SERVICE INFORMATION

Bulletin Nbr: 853-1751

Spacer washers as spare part for side consoles, seat-belt member

D853B612

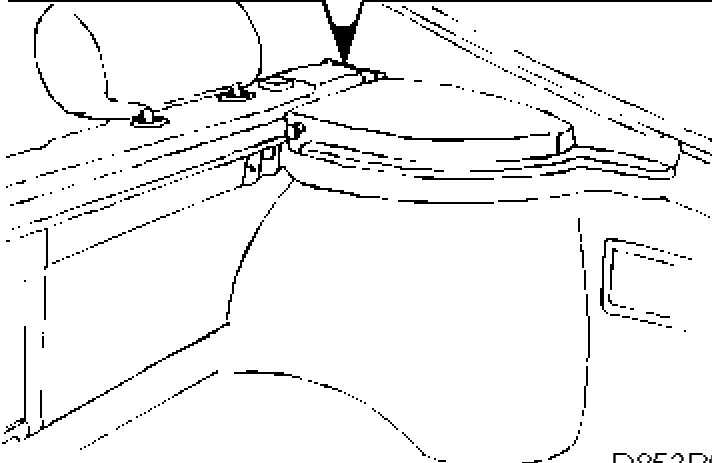
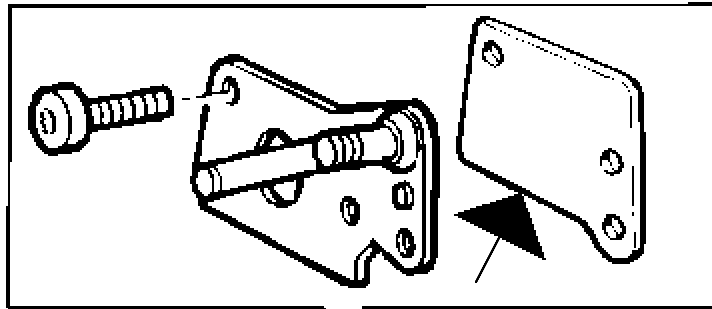
The body width varies between the 3- and 5-door cars. In order to avoid that the side console and the seat-belt member make contact during assembly, spacer washers in the materials kit as a spare part must not be used on 5 door cars.

When replacing the side console on 5-door cars, first check if there is a spacer washer behind the side console.

- If the car lacks a spacer washer, the spacer washer included in the materials kit must not be fitted.
- If there is a spacer washer, it should be refit.
